Warranty Extension: MIL Comes On with DTCs P0301 Thru P0304

Supersedes 13-079, dated June 13, 2018, to revise the information highlighted in **yellow**.

Year	Model	Trim	VIN Range
2010-12	Crosstour	V6	Check the iN VIN status for eligibility.

Under REPAIR PROCEDURE, a new tool is used to check any scratches in the cylinder bore.

52. Cylinder Wall Inspection. If vertical scratches are noted in the cylinder wall, refer to Job Aid Using Cylinder Wall Inspection Tool and or Tech2Tech "Using Cylinder Wall Inspection Tool".

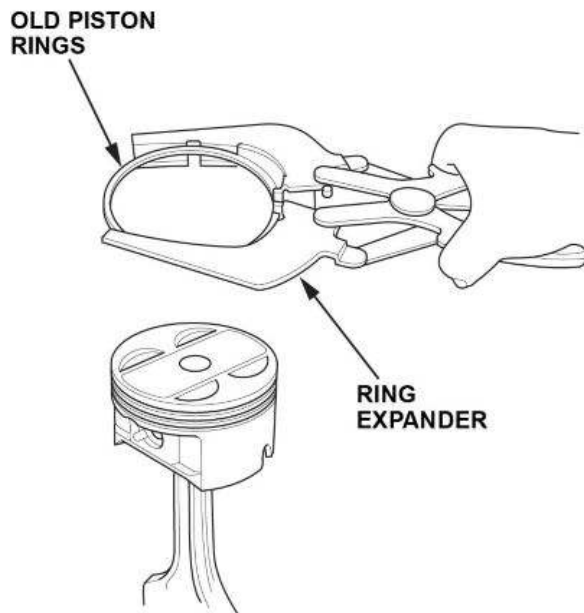
Do not use finger nail or pencil lead to determine if engine block is usable. Light to moderate scratches that are detected with your finger nail will pass the inspection when using the cylinder wall inspection tool.

- If the engine block is **good**, go to PISTON CLEANING PROCEDURE and clean the appropriate piston.
- If the engine block is **no good**, replace the engine block. The block comes with updated pistons. This bulletin no longer applies. You must obtain DPSM authorization and refer online to **Engine Removal and Installation** to reinstall the engine.
